ALTERNATE BID CHANGES (SEE PCC SIDEWALK THICKENED EDGE DETAIL FOR MORE DETAILS)

<p>Alfred Benesch & Company 35 W. Wacker Drive, Suite 3300 Chicago, Illinois 60601 312-565-0450 Job No. 10483.04</p>	USER NAME = bchavez PLOT SCALE = 10.0000" / 1' PLOT DATE = 6/4/2020	DESIGNED - B CHAVEZ DRAWN - T BLANK CHECKED - B CHAVEZ DATE - 06/05/2020	REVISED - REVISED - REVISED - REVISED -	CITY OF AURORA	PLAN AND PROFILE	SCALE: 1"=5'H, 2.5'V	SHEET OF SHEETS STA. TO STA.	F.A. RTE.	SECTION	COUNTY	TOTAL SHEETS	SHEET NO.
	ILLINOIS	FED. AID PROJECT	KANE					23	5

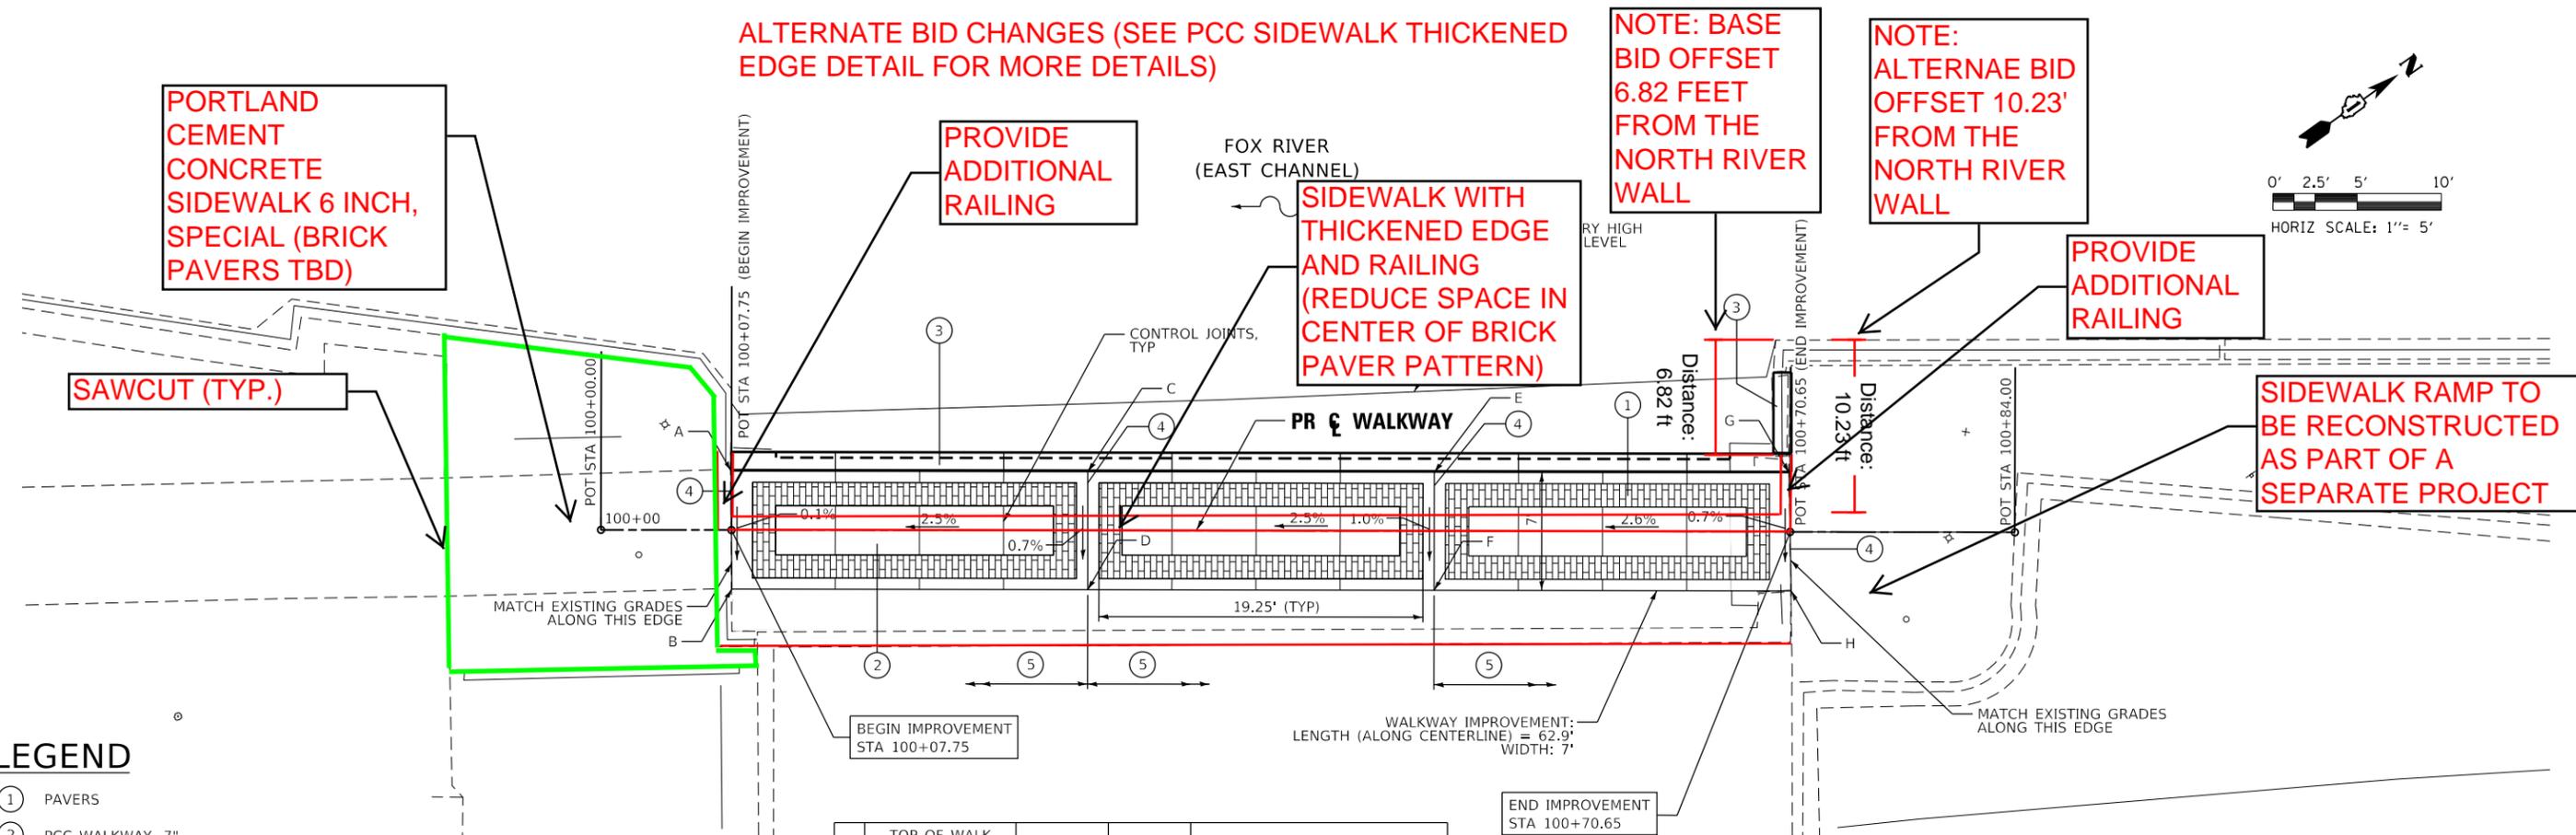
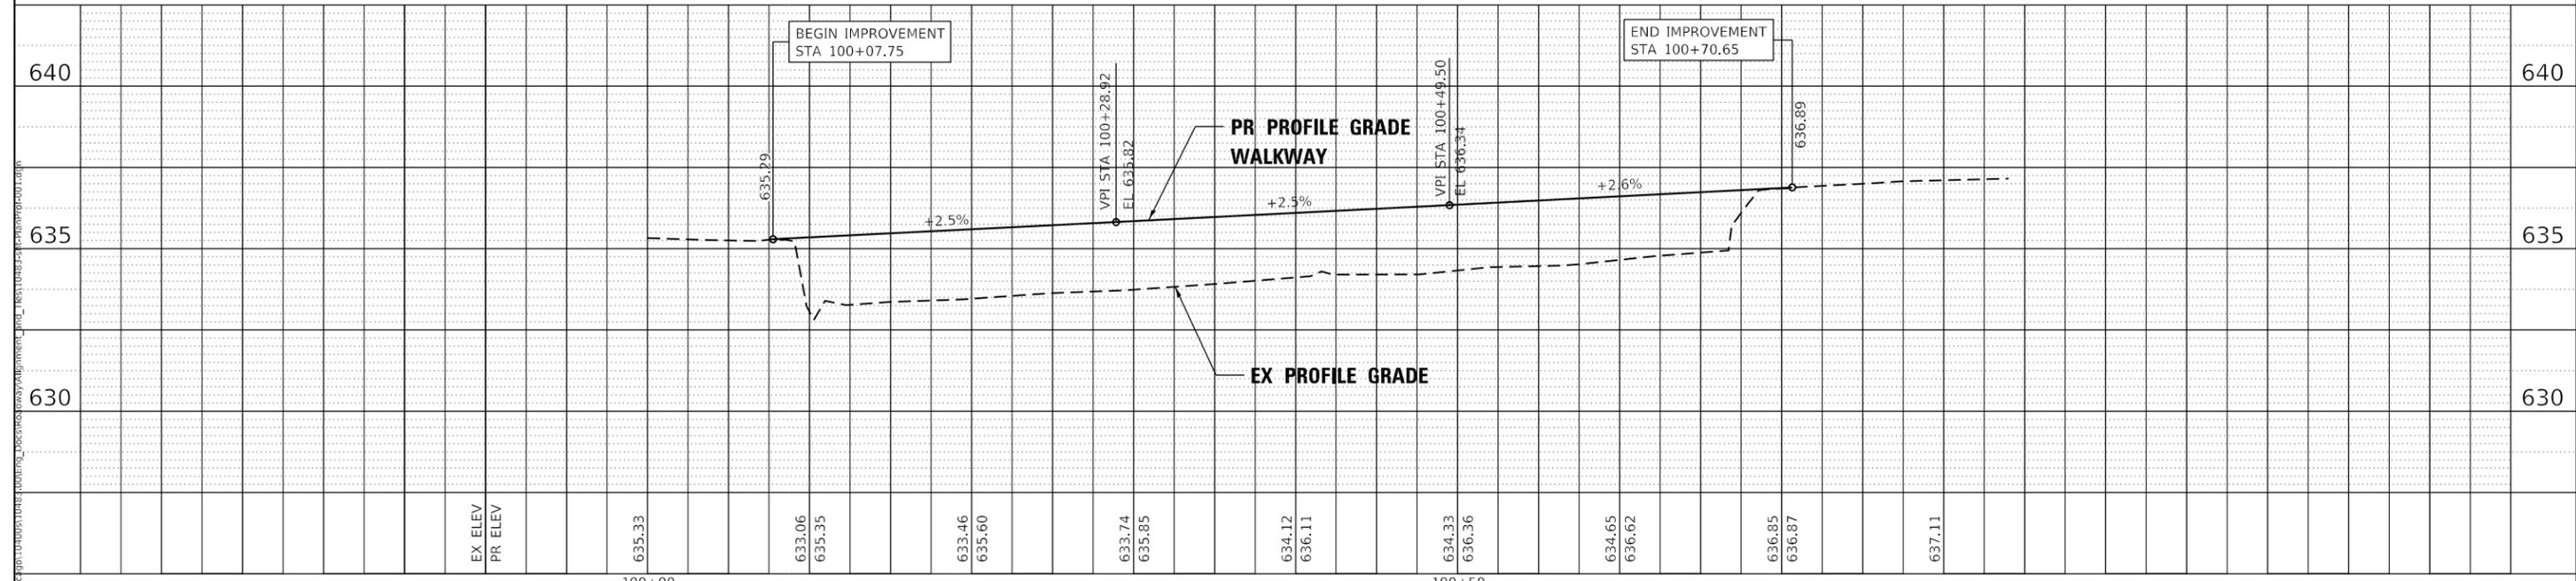
NOTE: ALTERNAE BID OFFSET 10.23' FROM THE NORTH RIVER WALL

PROVIDE ADDITIONAL RAILING

SIDEWALK WITH THICKENED EDGE AND RAILING (REDUCE SPACE IN CENTER OF BRICK PAVER PATTERN)

PROVIDE ADDITIONAL RAILING
